Sent: 5/03/2021 2:11:49 PM
Subject: DA2020/1247 CNR-13920 - AMENDED PLANS FOR UNDERGROUND TANK REPLACEMENT WORKS FOR EXISTING 7-ELEVAN – 940 PITTWATER ROAD, DEE WHY
Attachments: 20210212 - Response to TfNSW - Dee Why Petrol.pdf; swepts 210303.pdf; 20210305 - TfNSW Response SYD20_01230_02.pdf;

RE: DEE WHY 7-ELEVEN PETROL STATION
RESPONSE TO MATTERS RAISED BY TfNSW

**AMENDED PLANS FOR UNDERGROUND TANK REPLACEMENT WORKS FOR
EXISTING 7-ELEVEN – 940 PITTWATER ROAD, DEE WHY**

19.0m ARTICULATED
VEHICLE SWEEP PATHS

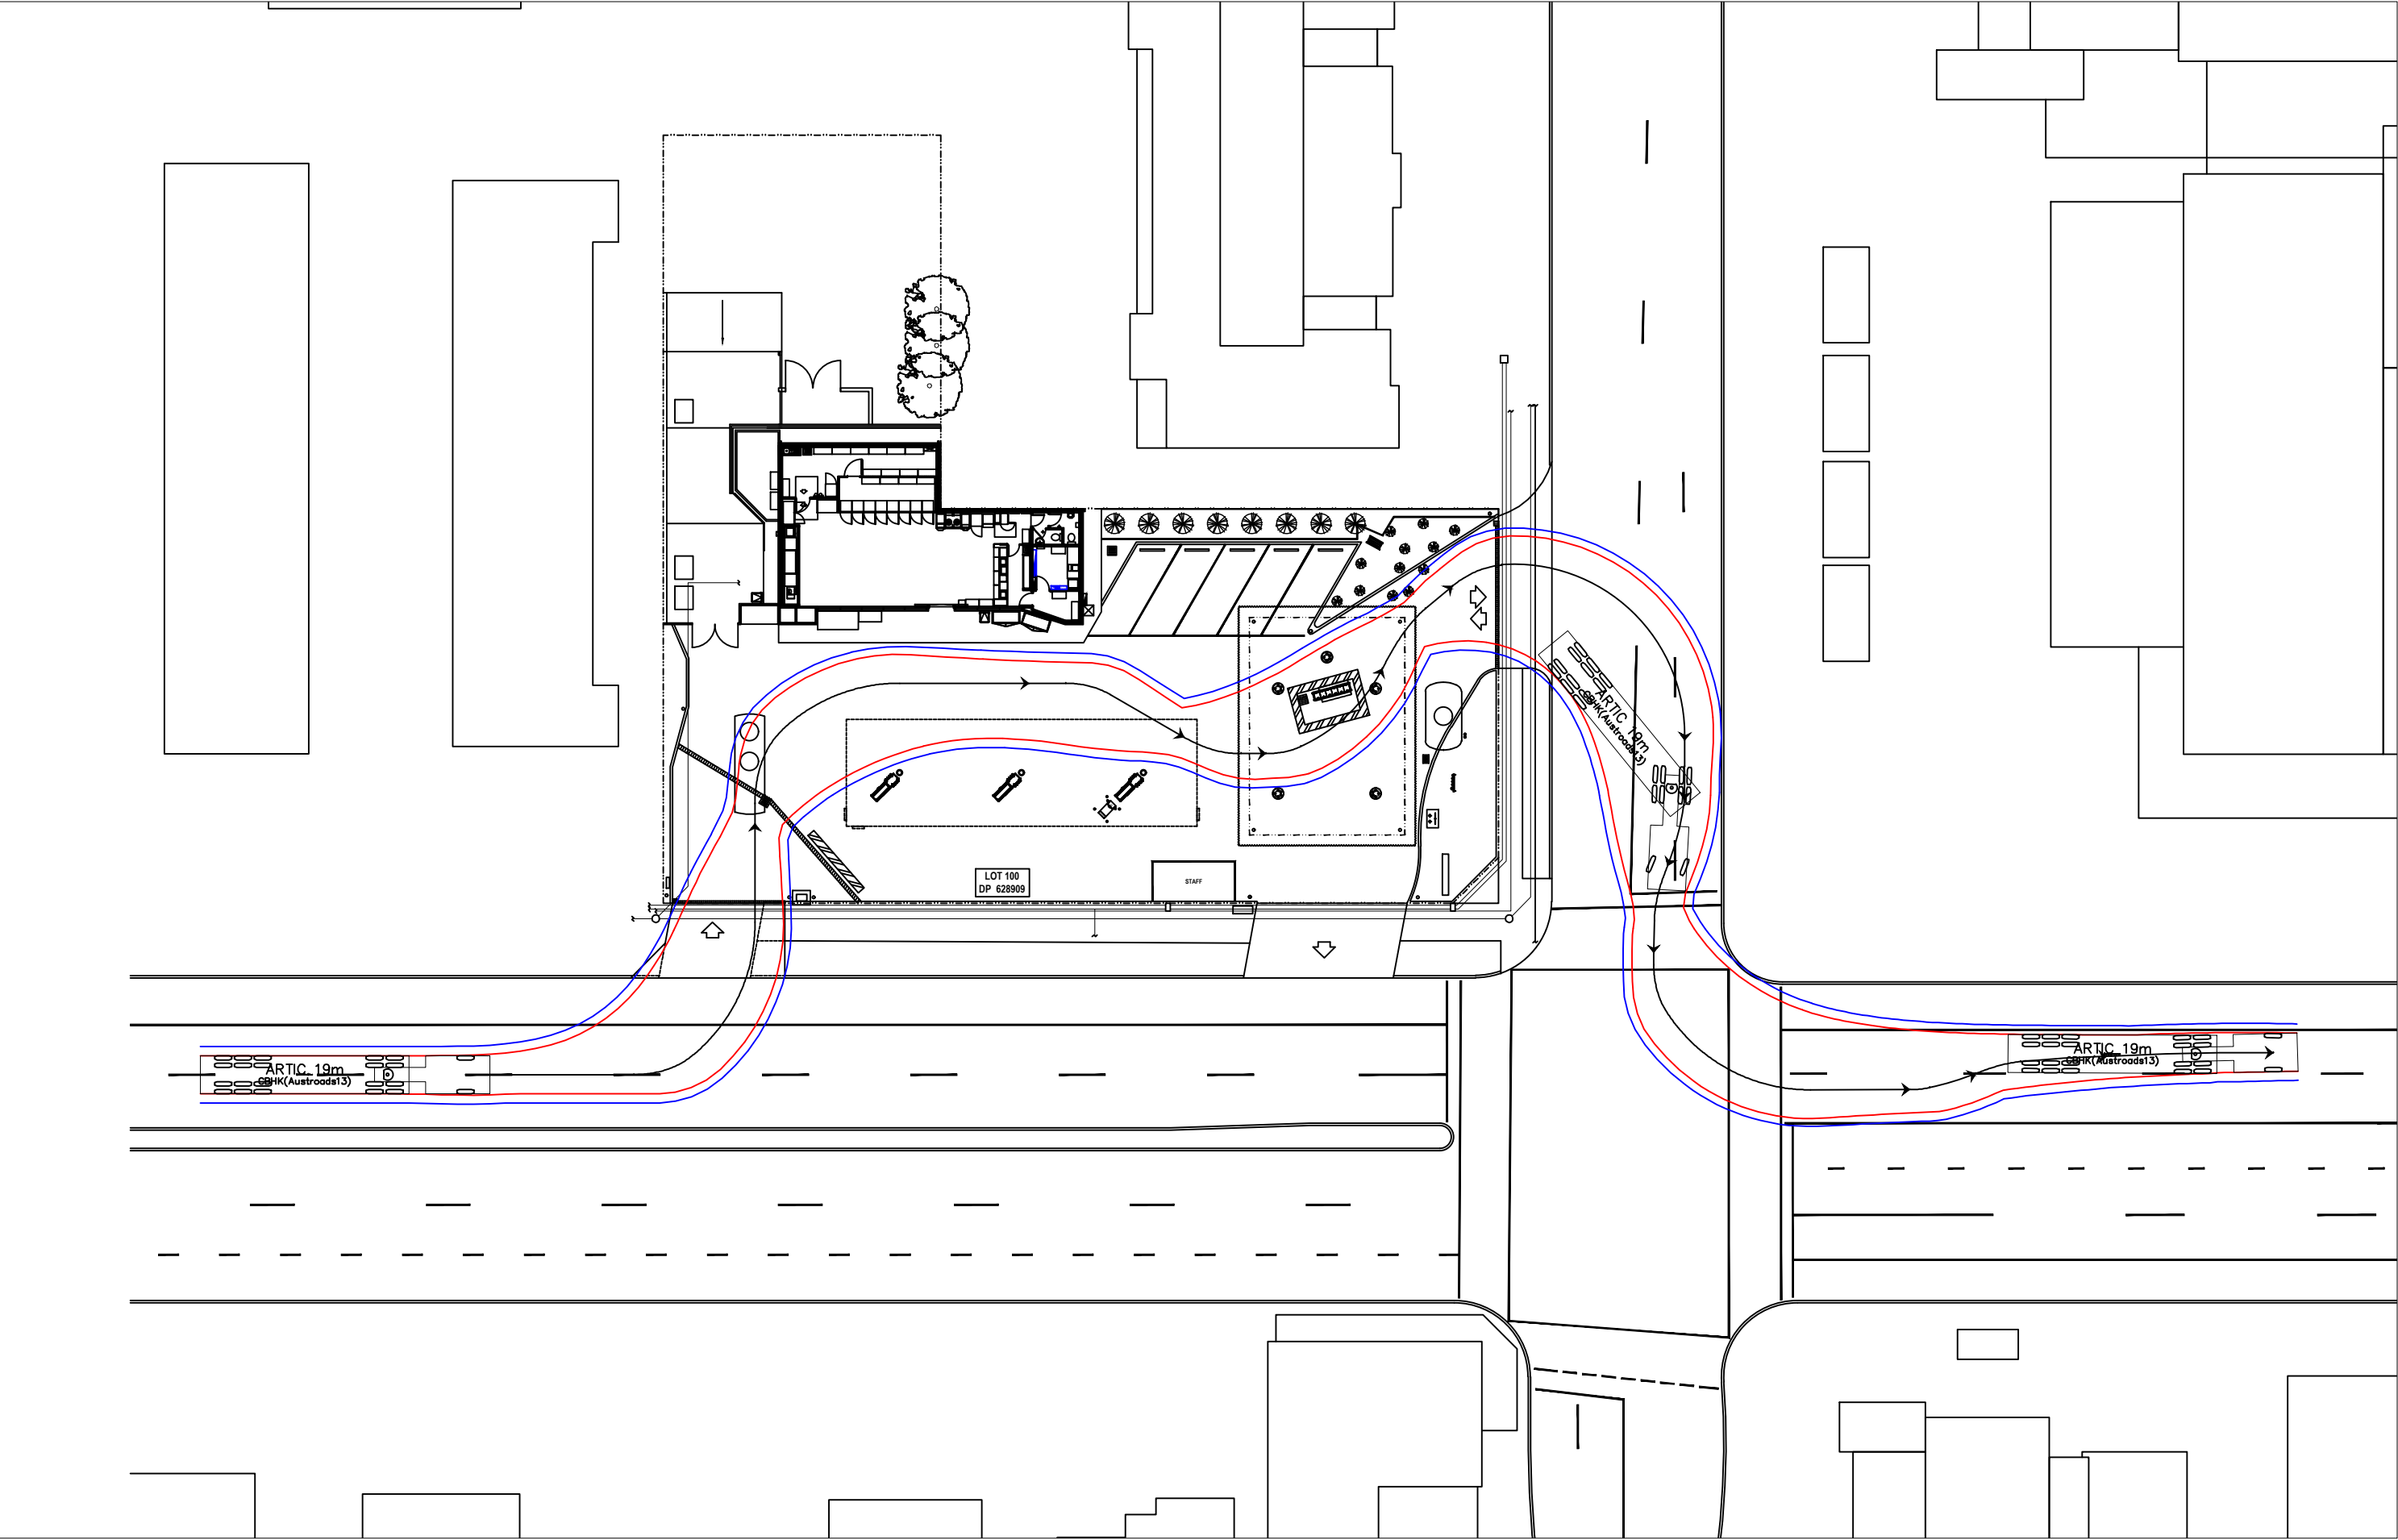
- ii. *Another option might be for the proponent to consider widening the first entry driveway on Pittwater Road for the tankers. However, this depends on whether the swept path analysis demonstrates that tankers can enter on Pittwater Road and exit on Hawkesbury Road in a forward direction*

3. Delivery tanker shall enter the site via the northern entry on Pittwater Road and exit via Hawkesbury Avenue as shown on the swept path plans provided. Vehicle over 8.8 meter long shall not enter/exit the site via the southern access point on Pittwater Road.

3. The tanker turn path (showing entry from the northern driveway (left turn from Pittwater Road and exit via a left turn onto Hawkesbury Avenue) is provided in Attachment B.:
